City of Fargo Staff Report			
Title:	Duane's Pizza Addition	Date: Update:	12/29/2022 2/16/2023
Location:	1601, 1605, 1615, 1617, 1619, 1621, 1623, 1627, and 1629 University Drive South; 1602, 1606, 1610, 1614, 1618, 1622, and 1626 13 ½ Street South; 1321 17th Avenue South	Staff Contact:	Maegin Elshaug
Legal Description:	Lots 1-8, less the vacated right-of-way and Lots 9-16, Block 28, Morton & Doty's Addition		
Owner(s)/Applicant:	BLOC Partners, LLC/Craig Development, LLC	Engineer:	Lowry Engineering/Neset Land Surveys
Entitlements Requested:	Zoning Change (from SR-2, Single-Dwelling Residential, SR-3, Single-Dwelling Residential, and LC, Limited Commercial to LC, Limited Commercial with a PUD, Planned Unit Development Overlay); a PUD Master Land Use Plan within the boundaries of the Duane's Pizza Addition; and Minor Subdivision (replat of Lots 1-8, less the vacated right-of-way and Lots 9-16, Block 28, Morton & Doty's Addition to the City of Fargo, Cass County, North Dakota).

Status:	City Commission Public Hearing: February 21, 2023

Project Summary

BLOC Partners, LLC proposes a 5-story mixed-use development, consisting of 127 residential apartment units, 15,258 square feet of com

Sheet Number:
MP1.0

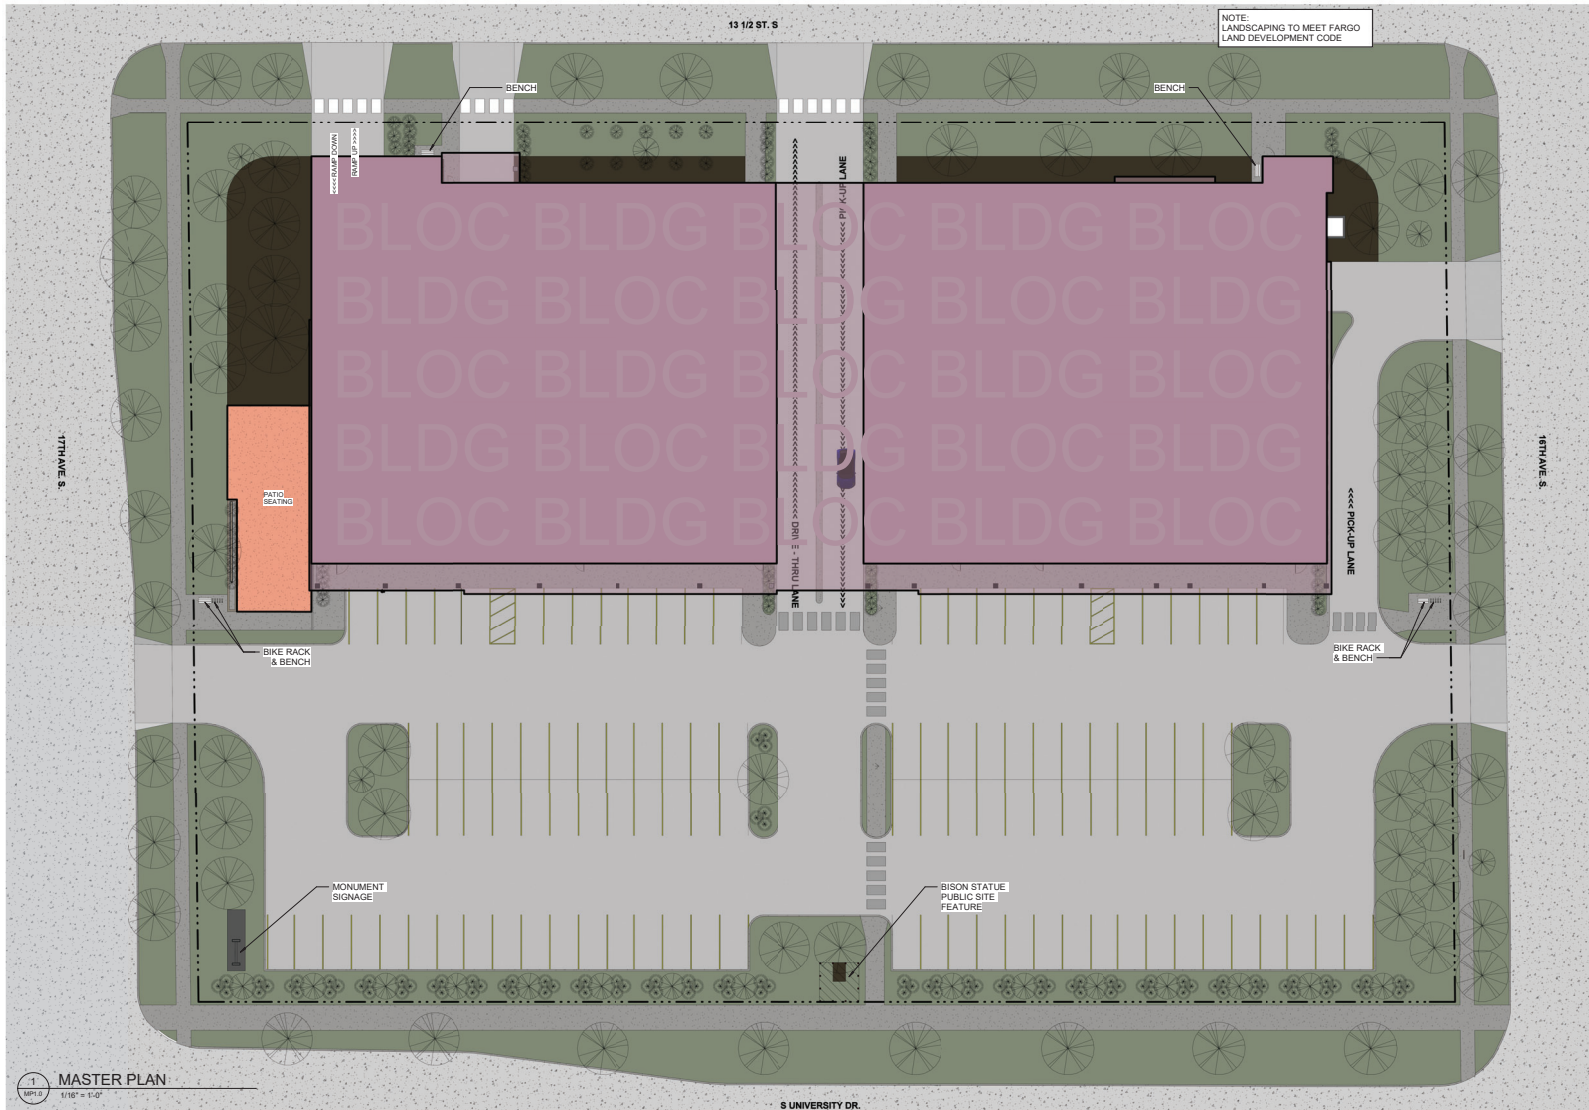
3. Building placement: Building should be located further east towards University Drive South. Your proposed location is counter to goals of Go2030 and the Core Neighborhoods Plan because your project is auto-oriented and not conducive to relating to pedestrian scale along west side with the neighborhood and University corridor.

When reviewing the site context and the future corridor, we are still considering the impact of the building placement in relation to the street and abutting uses. Staff does consider the aspects of keeping the existing businesses and that is an asset of the project. However, as per what was identified in the October 31th letter, we need a response to better indicate your position on the prominent vehicular focus. Additionally, below are concerns on the treatment of the following items:

- Provide cut sections and scale relationship to University and 13 ½ Street South as to better determine the building relationship, sidewalk and street relationships to each other.

- Provide cut section of pedestrian circulation and building arcade.

OVERALL
SITE
PLAN

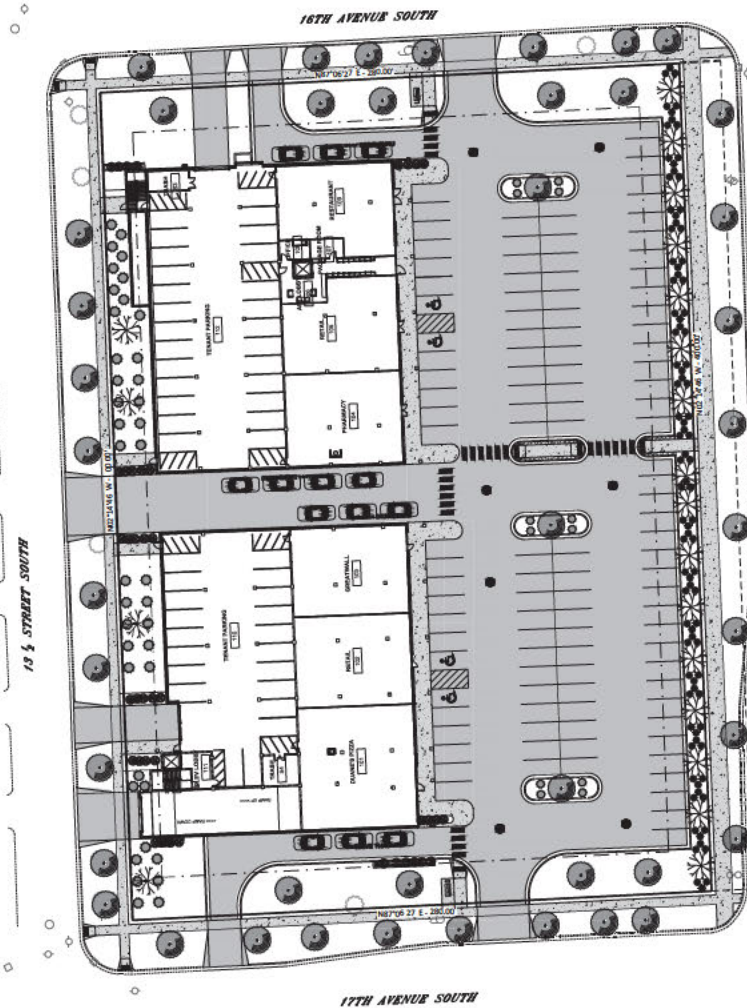
- Staff suggests the following as it relates to landscaping and pedestrian circulation, as well as integrating the landscaping plan as part of the PUD.

- Double required open space plant units
 - Remove 70% placement to allow greater flexibility and to address potential neighborhood impacts
 - Remove required maximum of perennial plantings to allow greater flexibility

- Provide vegetative buffer on north and south sides of parking lot and driveways along Avenues
 - Increase internal landscaped planting islands and push pedestrian connectivity to provide more buffer

- Provide additional screening of patio space
 - Consider additional planting amenity or pet space on northwest corner
 - Clearly define amenities of benches, bike racks, etc. on landscape plan
